KENWOOD

ASB-1056

Service Bulletin

Subject: TM-732A/E APC Circuit Improvement
2006

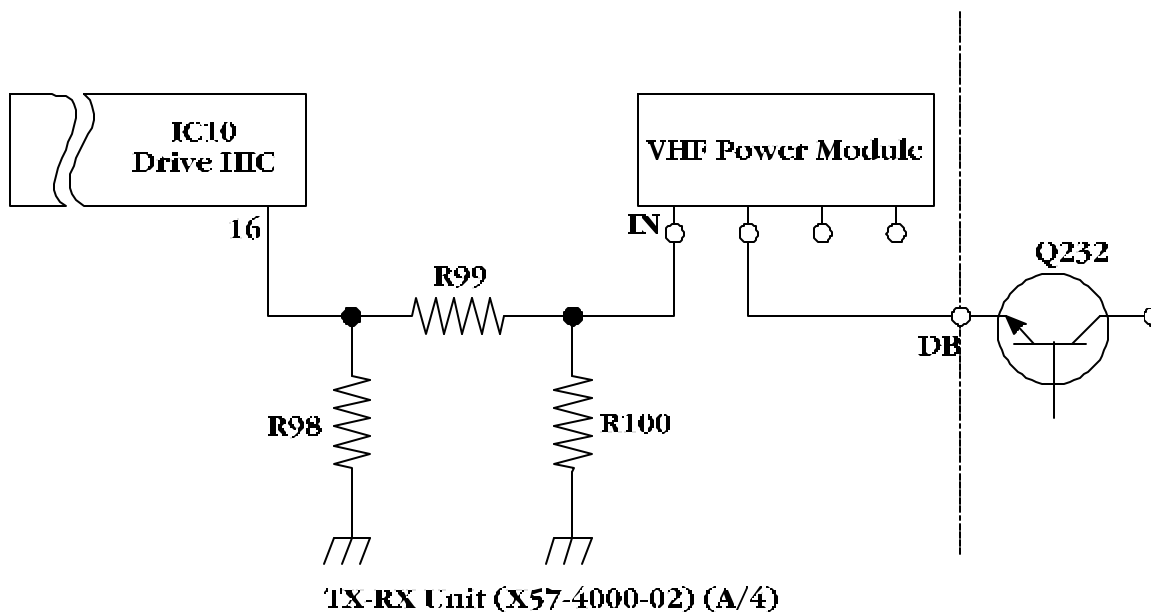
Failures of APC circuit transistor Q232 can occasionally be attributed to the gain dispersion characteristics of the VHF power module. Some of these devices allow normal transmit power output even with reduced "DB" terminal voltages. If the unit is then operated for extended transmit key down periods Q232 can overheat and fail.

1. Measure the transmit power output and the "DB" terminal voltage at a dial frequency of 145.020 MHz.
2. Add the 1 dB circuit if the transmitter power is 60 W or greater and the "DB" terminal voltage is 10 vdc or less.
3. After adding the attenuator, re-adjust the transmitter output power for 50 W and check the "DB" voltage. The "DB" voltage should now fall between 10 and 11 vdc. If it does not adjust the values for R98, R100, and R99 until this voltage range is obtained.

Pad Attenuation	R98, R100	R99
1 dB	820 ohm	5.6 ohm
2 dB	470 ohm	10 ohm
3 dB	270 ohm	18 ohm
